LIGHTING

1. Front Exterior Light

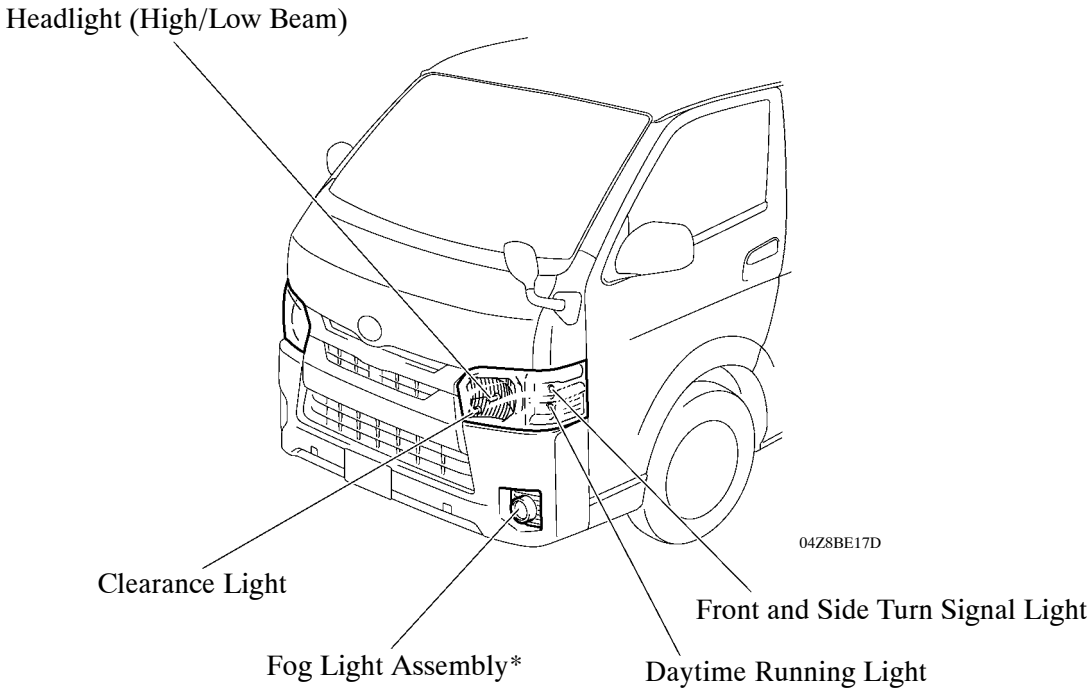
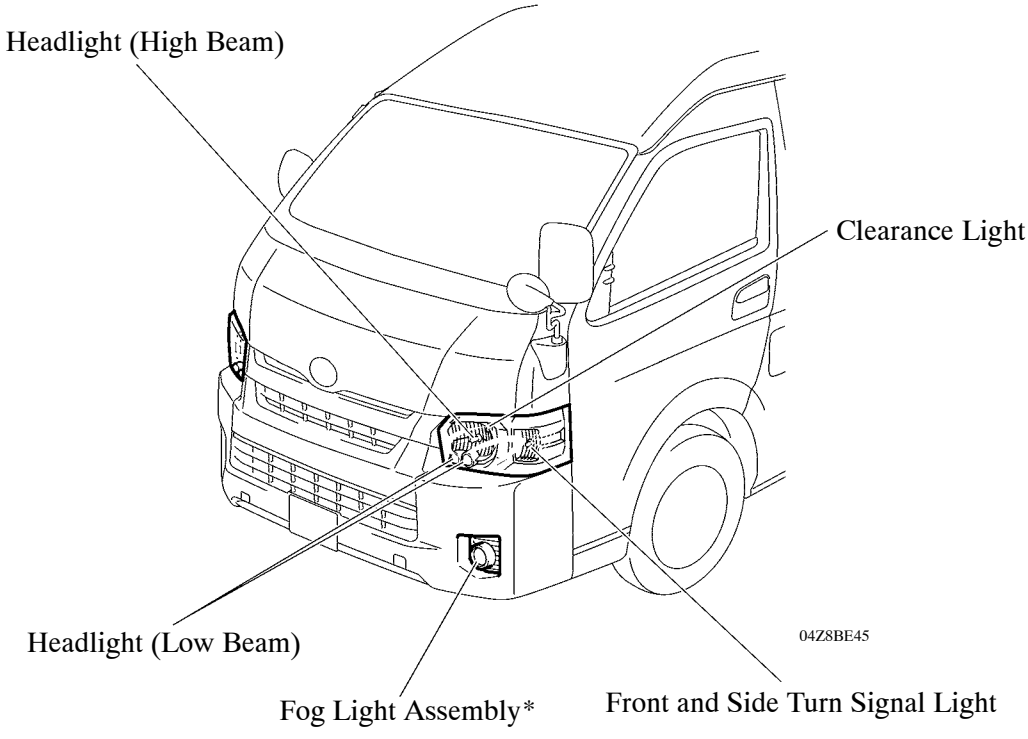
- The design of the halogen headlight assemblies has been changed.
- The halogen headlight assembly with daytime running lights have been adopted and provided depending on the specifications.
- LED headlight assemblies have been provided depending on the specifications.
- Along with the design change of the front bumper covers, the mounting positions of the fog light assemblies have been changed.*
- The HID headlight assemblies have been abolished.

2. Rear Exterior Light

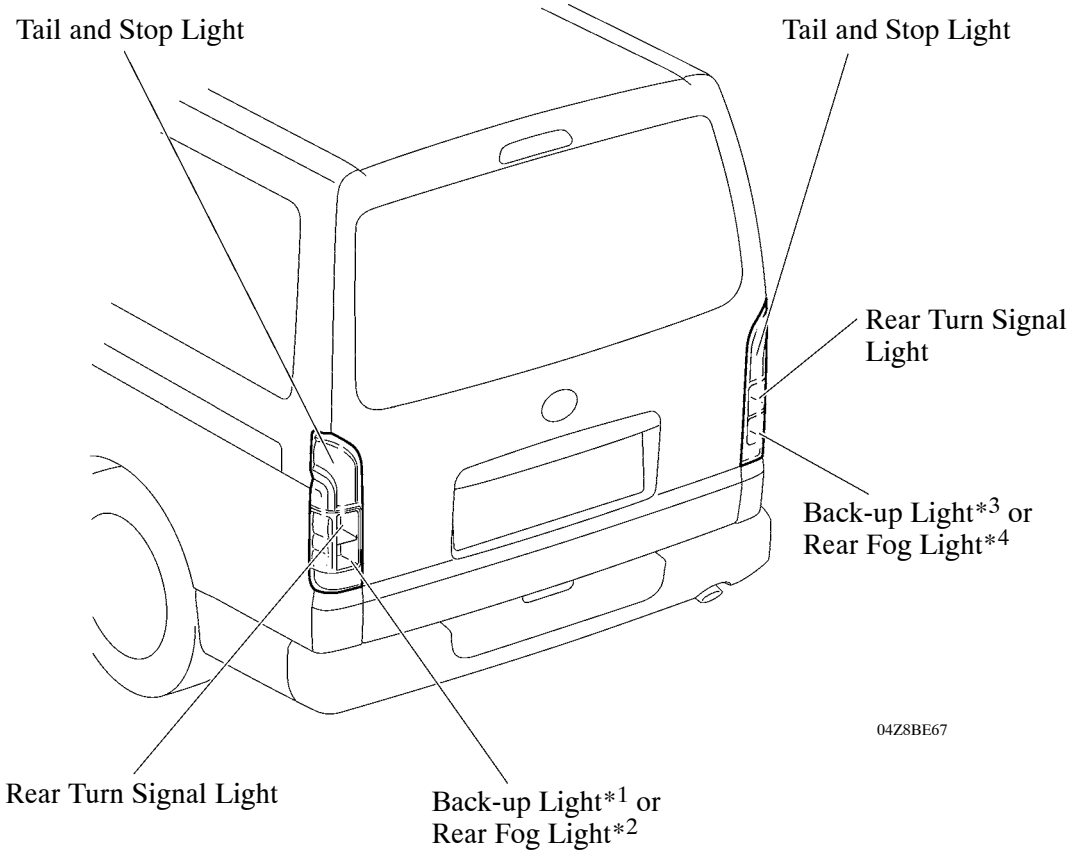
The design of the rear combination light assemblies for some models has been changed.

3. Interior Light

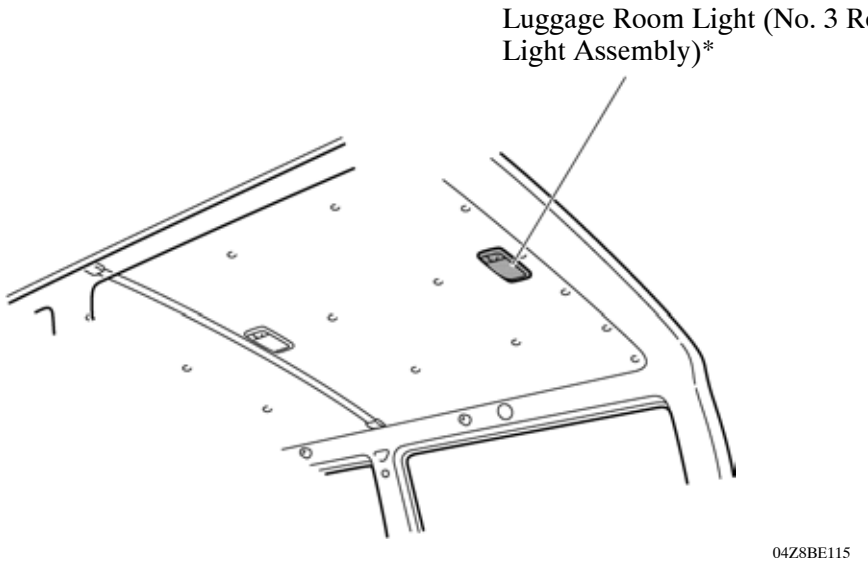
- A luggage room light (No. 3 room light assembly) has been provided at the roof on the rear of the standard body of vans and commuters to improve workability at night.

No. 1 Room Light Switch Assembly

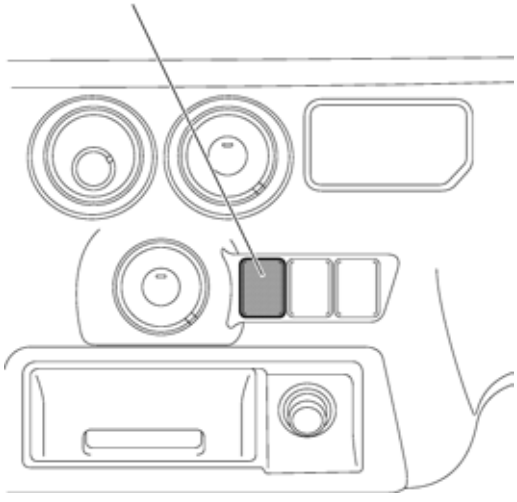
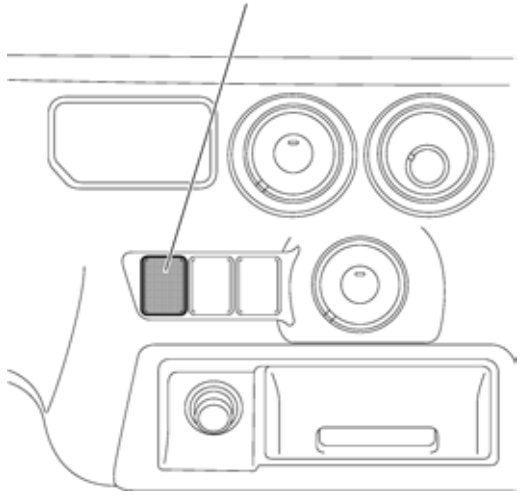
- The design and shape of the No. 1 room light switch assembly have been changed.*
